**SB-10046940-2495**SI M17 09 12  
Cooling SystemsAugust 2012  
Technical Service

**SUBJECT****Service Action: Retrofit of the Engine Coolant Temperature Sensor****MODEL**

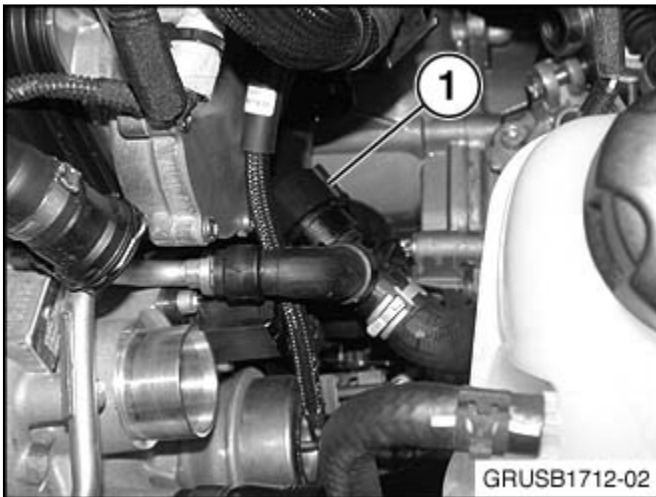
Remove the coolant hose (1). This hose will not be reused.

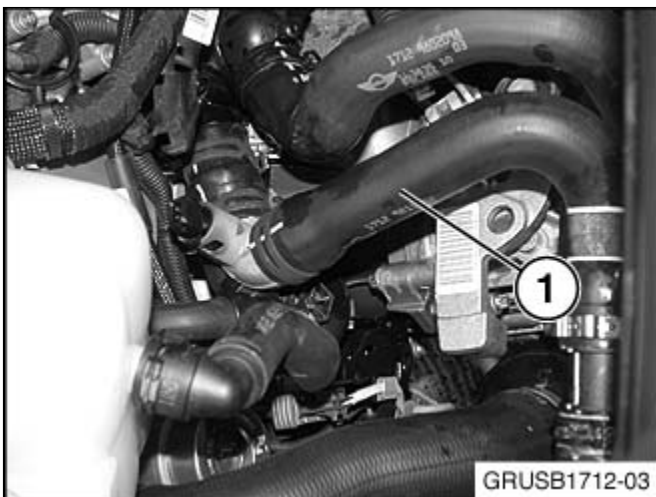
**N18 engine only!** Install spacer P/N 64 53 7 578 707 (1) on the coolant line as shown.

Note: The spacer needs to stay in this position when installing the new coolant hose P/N 17 12 7 647 009 (next step).

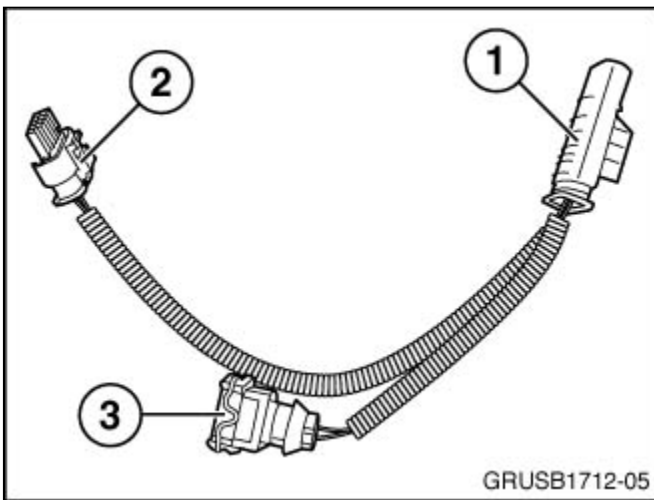
Install the new coolant hose with sensor P/N 17 12 7 647 009 (1).
